ADDENDUM

PROJECT: DOT-200009 Putnam County FSMF

DATE: 02/21/2025

ADDENDUM NO.: 1

A2.2
WASH BAY AND MAINTENANCE
BAY FLOOR PLAN

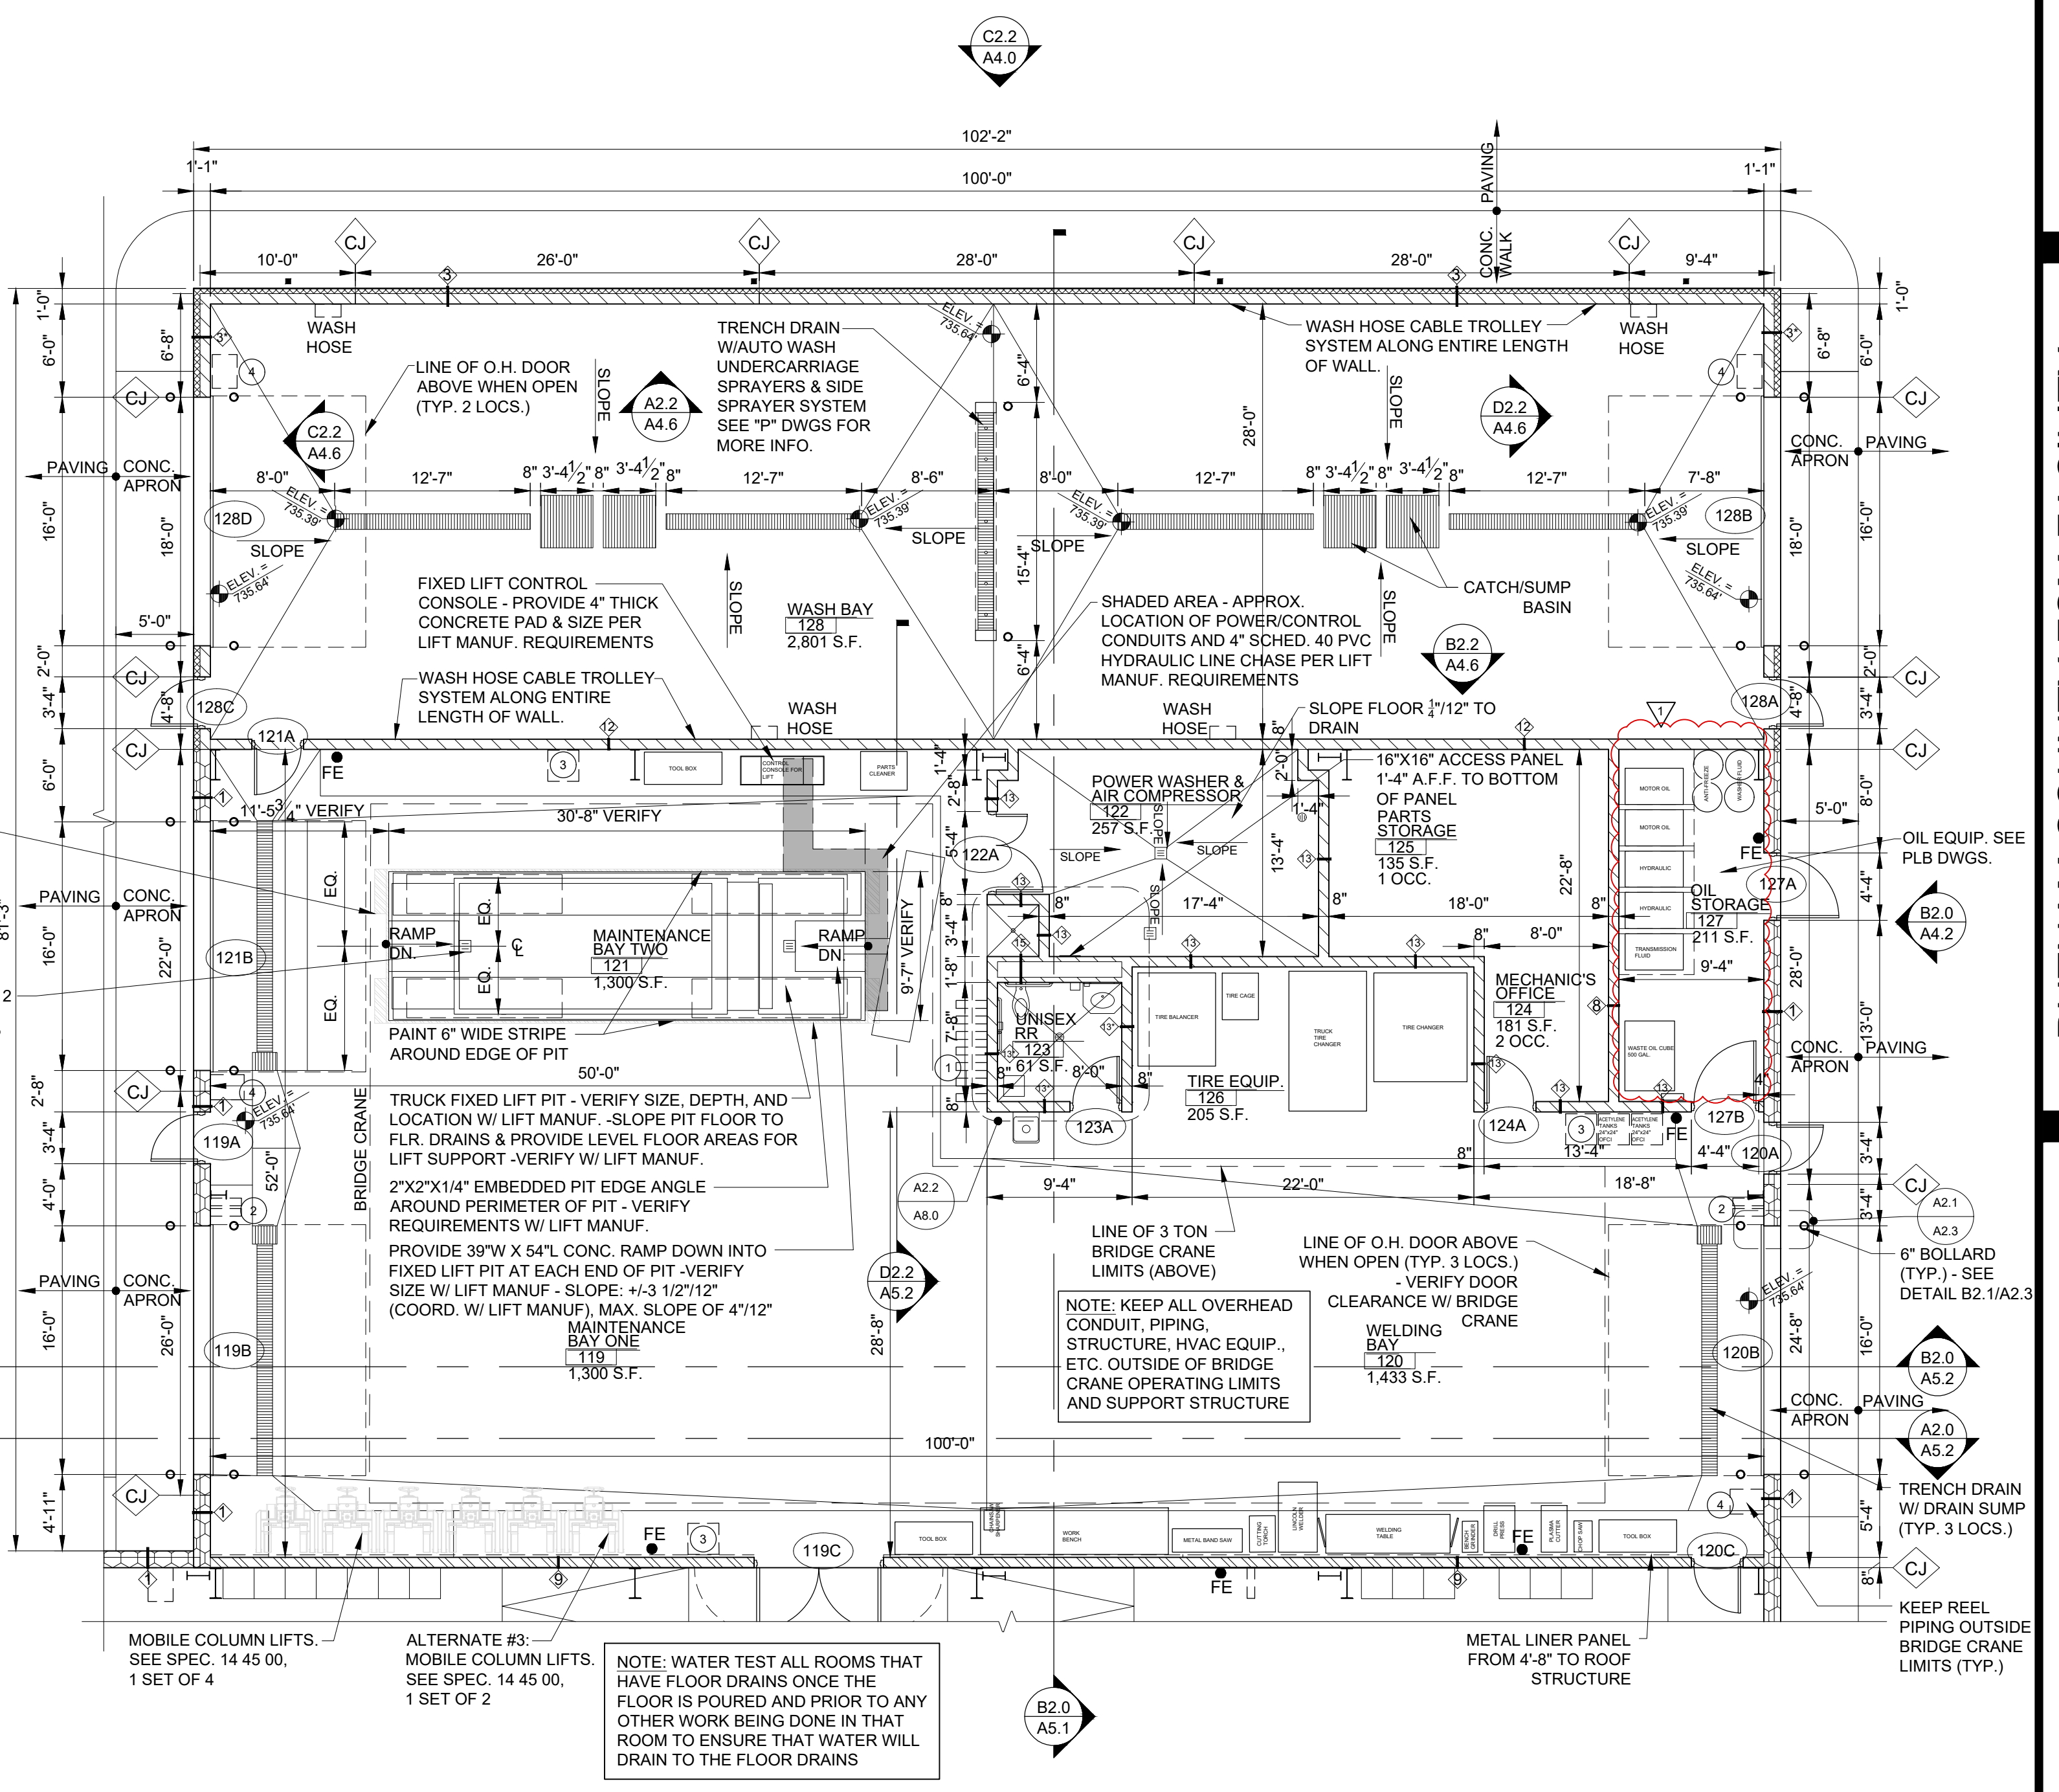
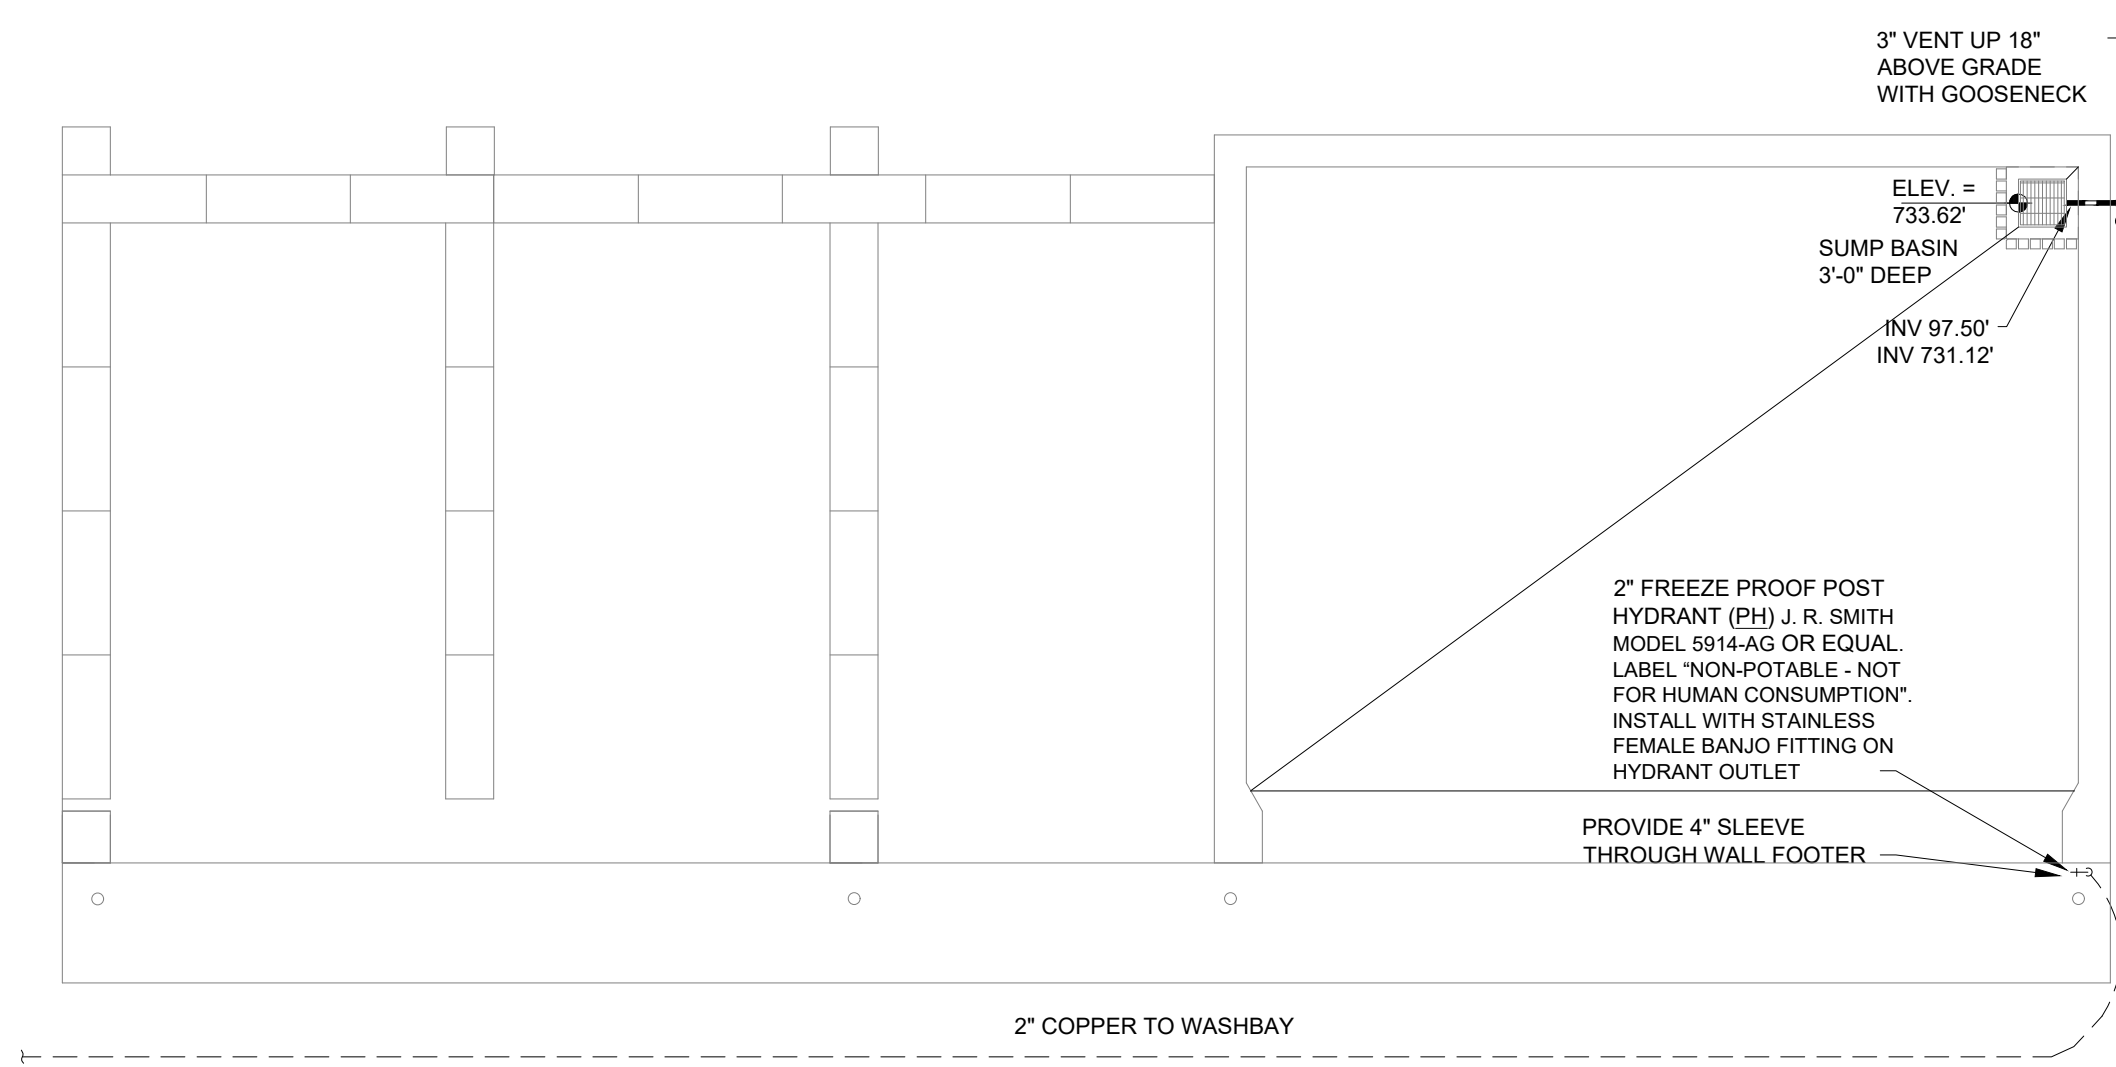
Item #12 Sheet A2.2 Wash Bay and Maintenance Bay Floor Plan

- Revision: Fire extinguisher was added to the Oil Storage Room (Room #127).
- Clarification: The Maintenance Reel Schedule has been updated to match the oil storage room plan.
- Revision: Please see revised drawing for layout of oil storage room.

P2.2
WASH BAY, MAINTENANCE BAY, & BRINE SHELTER PLUMBING PLAN

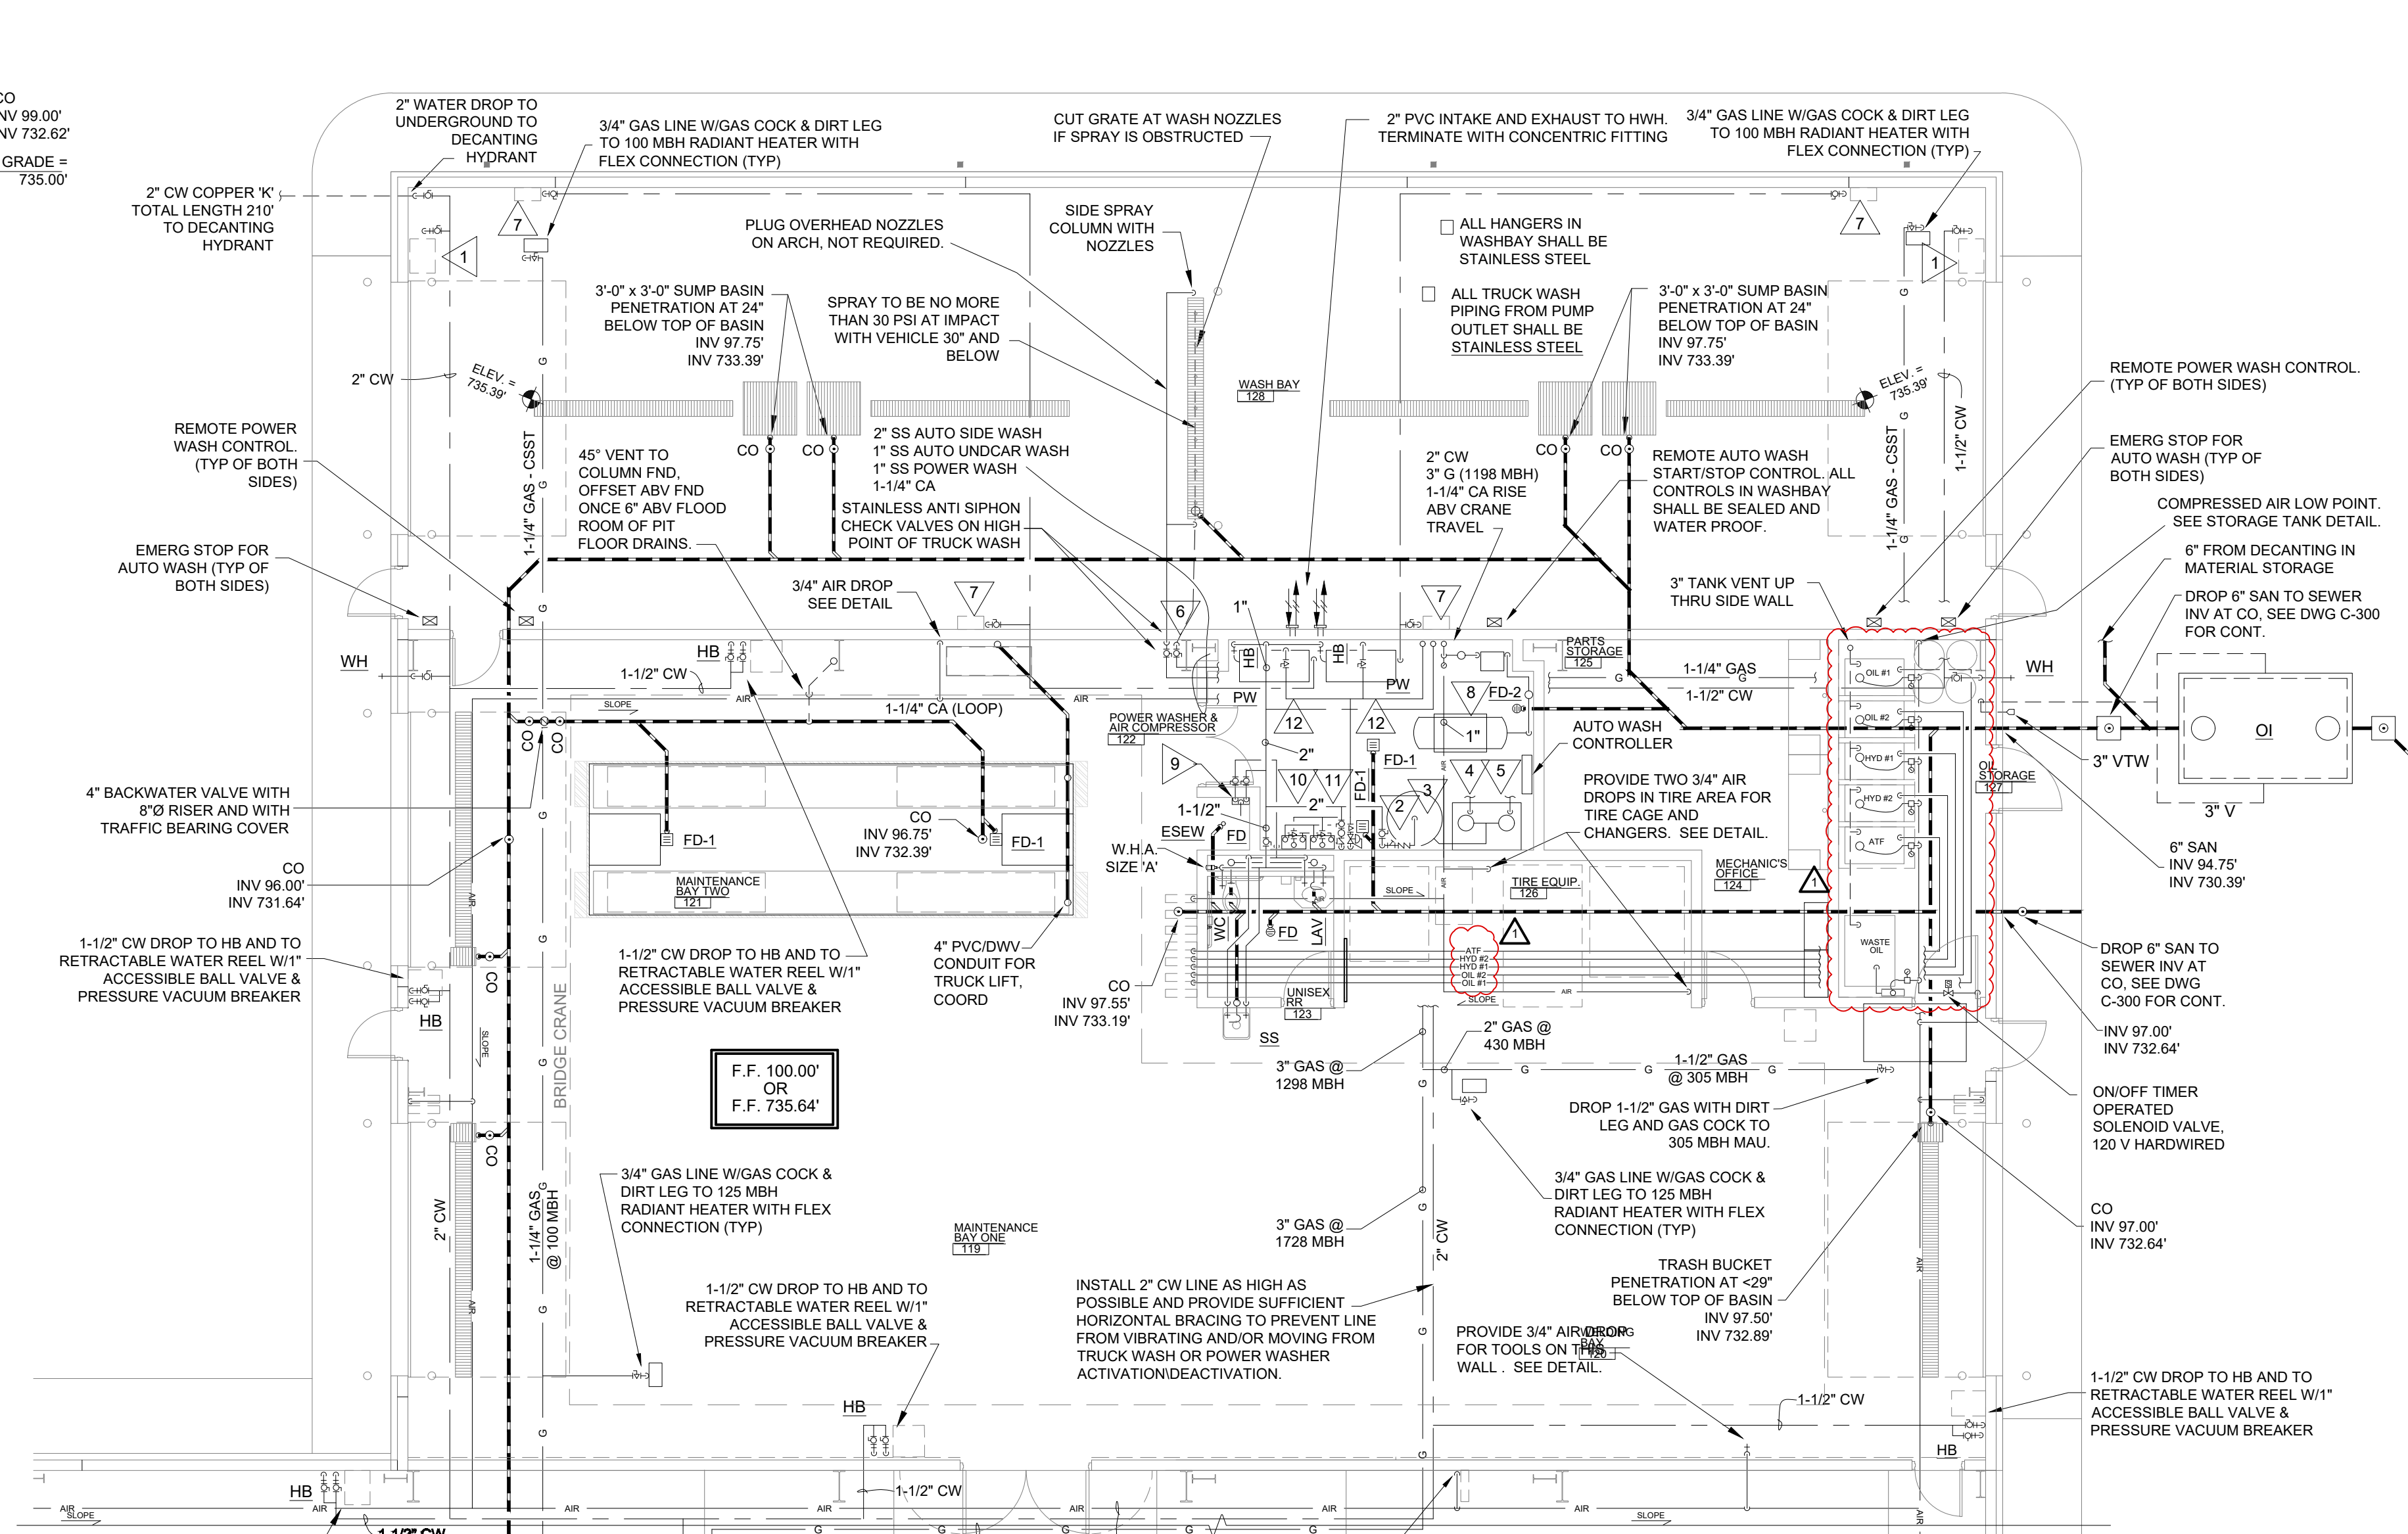
Item #13 Sheet P2.2

- Clarification: The dispensing fluids and waste oil as shown on drawing A2.2 and P2.2 has been revised. Bulk Lubrication Storage Tanks shall be Motor Oil #1, Motor Oil #2, Hydraulic Oil #1, Hydraulic Oil #2, ATF and waste oil. The bulk storage tanks are 275 gallons for dispensing fluids and 500 gallons for the waste oil tank.
